SUPPLEMENTAL/BID BULLETIN NO. 1
For LBP-HOBAC-ITB-GS-20210603-02

PROJECT : Precision Airconditioning Unit (PACU) for LANDBANK
Data Center Head Office

DATE : July 30, 2021

Annex A

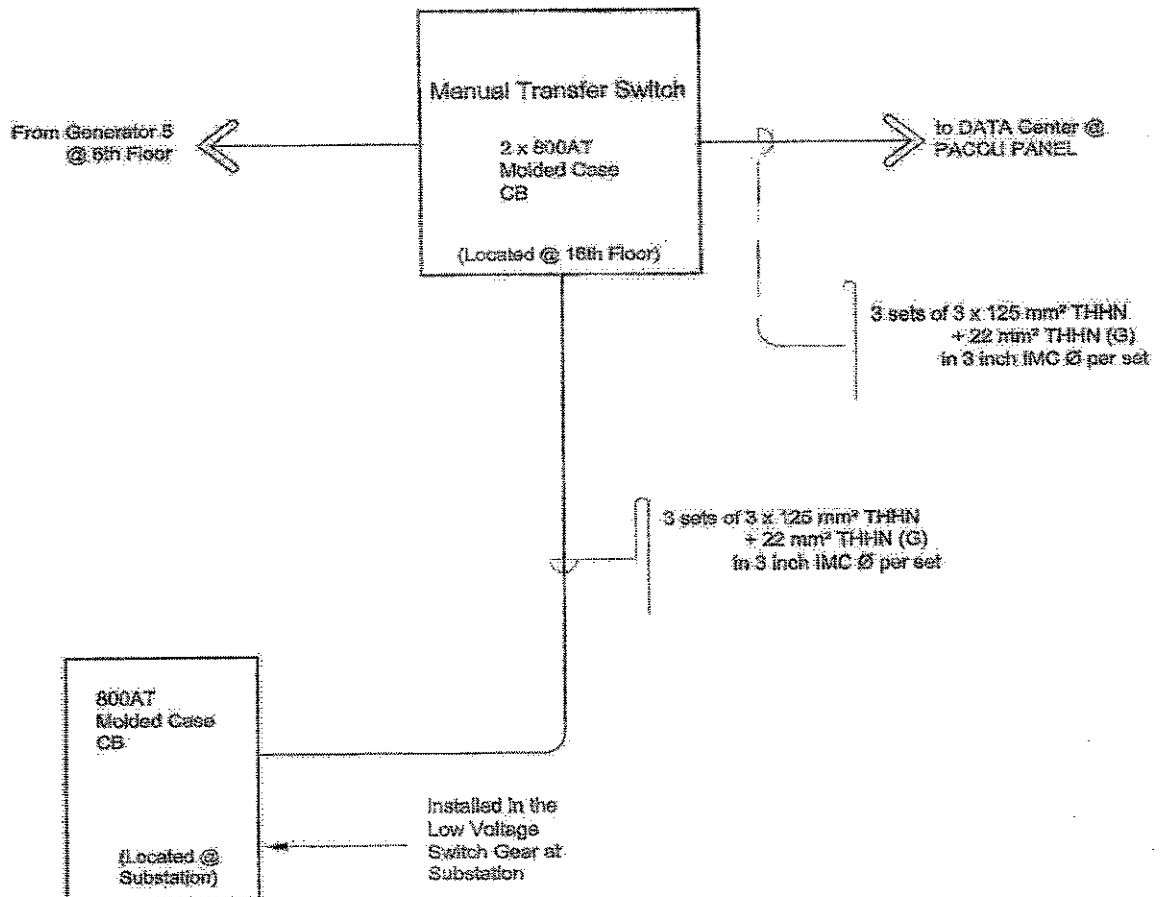
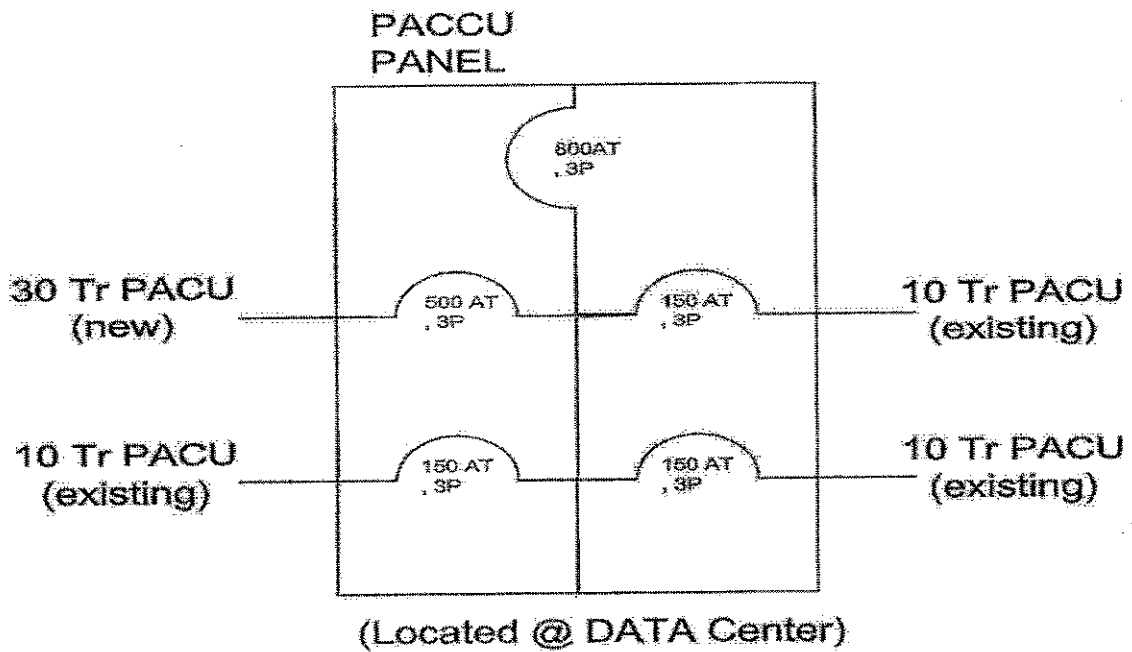
<p>the lowest speed, separating the oil from the refrigerant directly inside the compressor.</p> <p>The direct control via the Simple Network Monitoring Protocol (SNMP) a continuous monitoring of the compressor operating conditions is possible with direct access from the terminal unit, or remotely via connection to supervision systems and building management systems (BMS).</p> <p>The inverter control system, the brushless DC motor and the "High Pressure Shell" system, it is possible to ensure the system high functional efficiency, minimizing the need to service the cooling circuit.</p>		
Piping	Winning Bidder must provide new condensate drain and water supply tapping points of the new PACU, tapping must be on the nearest comfort room.		
Electrical	Winning Bidder must provide new electrical feeder-line for the new PACU Indoor and ACCU/Outdoor unit		
	Winning Bidder must replace all electrical system of the previous PACU line. Use attached schematic diagram. (Annexes A and B)

Winning Bidder must include new electrical conduit for the PACU ACCU/Outdoor unit suitable for outdoor condition		
	Winning Bidder must supply and install necessary and required electrical cables and conduit.		
	Proponent Unit to provide suitable power to accommodate power requirement of new PACU and Intelligent Fan system.
